URGENT – FIELD SAFETY CORRECTIVE NOTICE

**GETINGE 88-5 Washer disinfectors
Field Action 1303821 – CAPA 1287961**

Date:	August 15, 2025
Product Issue:	A Getinge 88-5 washer-disinfectors caught fire due to overheating of the heater element, caused by absent or incorrect calibration of the circulation pressure sensor.
Affected Product:	Getinge 88-5 Washer disinfectors (all units with electrical heating) Only those units identified in the below list of affected serial numbers for your market were identified to be affected.
UDI DI	07340153700109 07340153700116
SRN	SE-MF-000001012
Resolution:	Getinge proposes to verify that the pressure in the circulation system reads 0.0 kPa during stand-by mode to make sure all devices present in the market are working effectively and safely. If the pressure does not indicate 0.0 kPa, the device must be calibrated by a qualified technician. An instruction will be provided to support the verification process.
Affected Serial Nos.:	See the below list of affected serial numbers for your market.

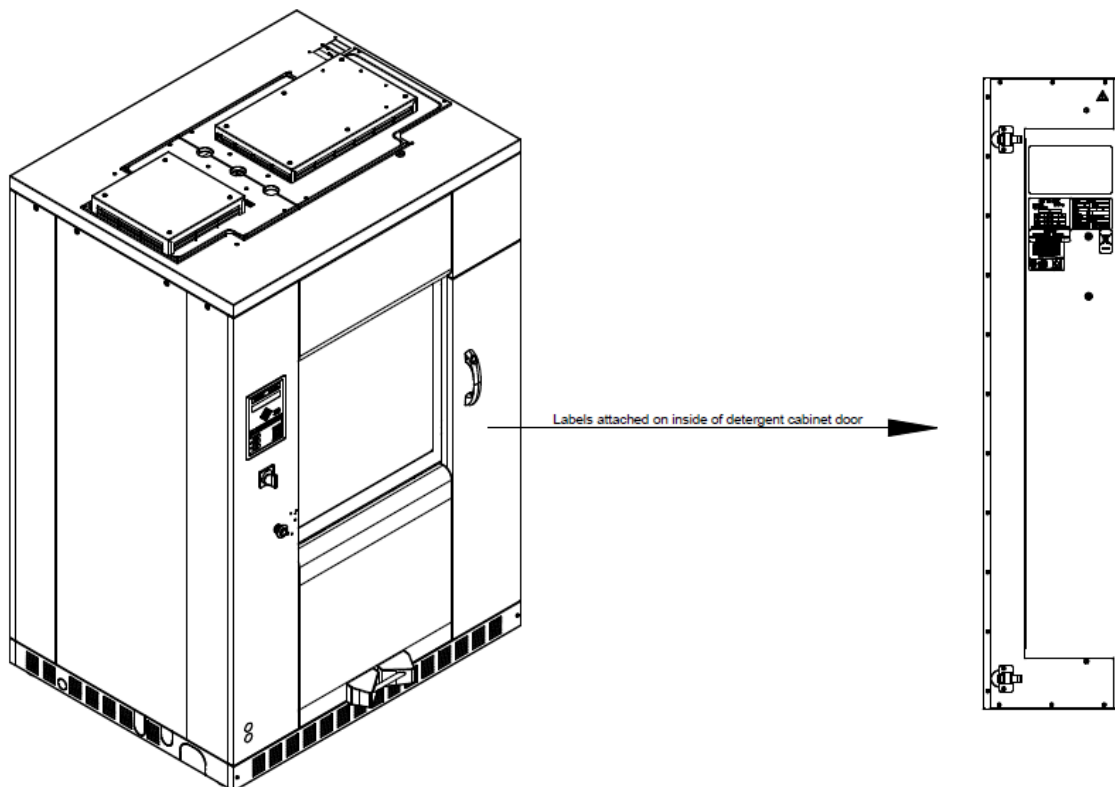
1. Check the serial number of your Getinge 88-5 Washer disinfectant. The serial number shall correspond with the serial number on the customer response form (Appendix 1).

The serial number is located on the marking label attached to the machine. This label is placed on the inside of the detergent cabinet door, see picture below:
